P 522422

ON-SITE SEWAGE DISPOSAL SYSTEM HOWARD COUNTY HEALTH DEPARTMENT BUREAU OF ENVIRONMENTAL HEALTH

SUBDIVISION: Waterford Farms LOT NUMBER: 42

ADDRESS: 3256 Eleanors Garden Way PROPERTY OWNER: Toll MDII LP

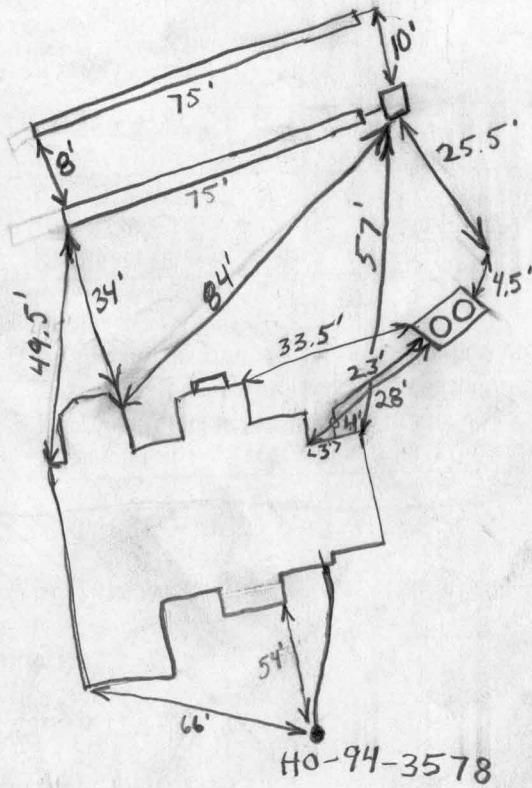
TRENCHES:	Trench to be 3.0 feet wide. Inlet 3.0 feet below original grade. Bottom maximum depth 5.0 feet below original grade. Effective area begins at 3.0 feet below original grade. 2.0 feet of stone below distribution pipe.
LOCATION:	Place the distribution box at the highest elevation within the approved sewage disposal area.
NOTES:	Effluent filter needed. <u>ENSURE S. Tank NOT IN MANMADE SWALE</u>

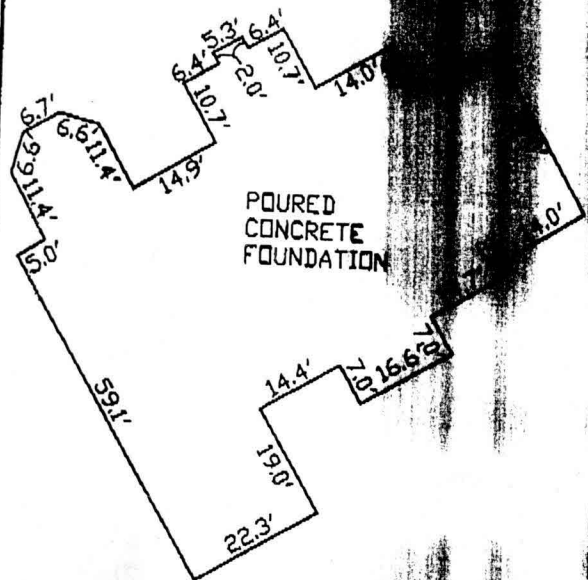
PRE-CONSTRUCTION 2 x 75' trenches 5' inlet - 4/26/05 Install 2 x 75'
trenches on contour to best utilize the closest part of the easement to the house

INSTALLATION 4/28 First Trench (closest to house) 5' inlet - Furthest
from house 4'-6' inlet. Trenches installed as instructed.
